**REQUEST FOR ADDITIONAL INFORMATION
ON AIRCRAFT HAZARDS—CLARIFICATION
DOCKET NO. 72-22 / TAC NO. L22462
PRIVATE FUEL STORAGE FACILITY
PRIVATE FUEL STORAGE L.L.C.**

PFS Answers to NRC Questions Regarding Aircraft Hazards to the PFSF, April 25, 2001

NAV Mode HSI Display.

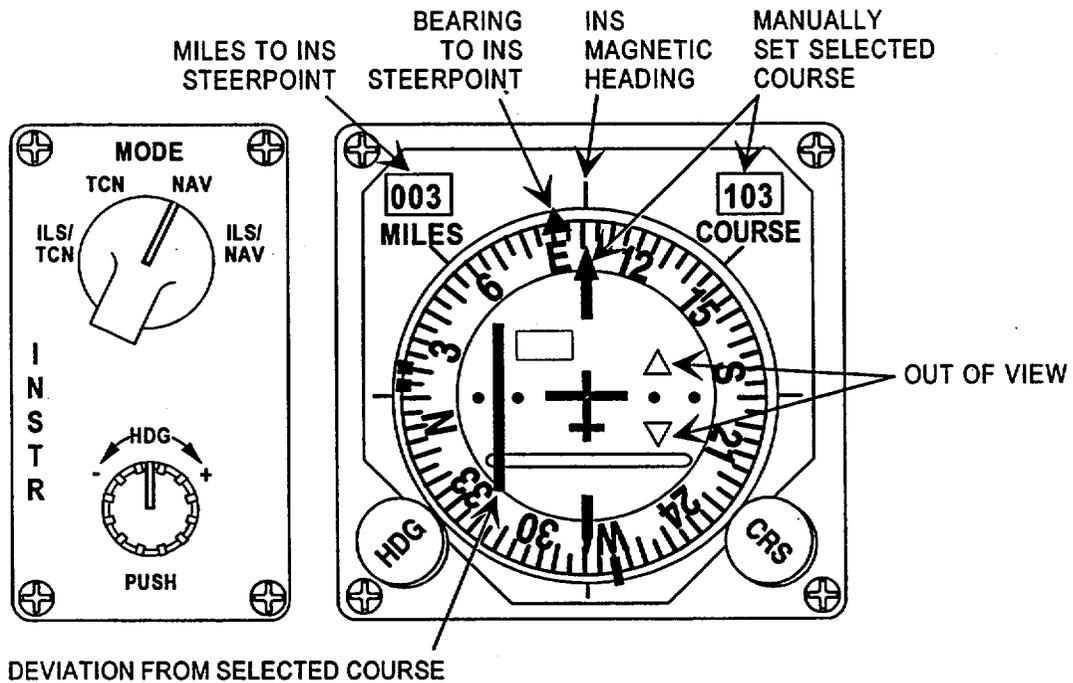
4. If there were cloud cover in Skull Valley, how would the pilot maintain awareness of the location of the PFSF site, including the use of aircraft instruments such as the INS to do so?

One of the onboard instruments the pilot would use is the Horizontal Situation Indicator (HSI, see attached example).³ This displays bearing and distance to the selected navigation or steering point and can be used to fly an exact course to the point. In the attached example, the selected navigation point is bearing 090⁰ for 3 miles. Further, it shows that the airplane is to the right of the 103⁰ course selected by the pilot. If the pilot wanted to correct back to the course, he would need to turn left. If the pilot were on course, then the large bar marked "Deviation from Selected Course" (in the drawing) would be centered and it would form a straight line with the "arrow point and tail" in the center of the display. Thus, pilots can maintain a precise course (also referred to as ground track) to the desired point.

When NAV is selected on the instrument mode select knob the following data displays on the HSI: INS magnetic heading, bearing to INS steerpoint, miles-to-go, course deviation, and course set from the selected INS steerpoint (Figure 17). The NAV mode does not change HUD symbology from the standard navigation displays.
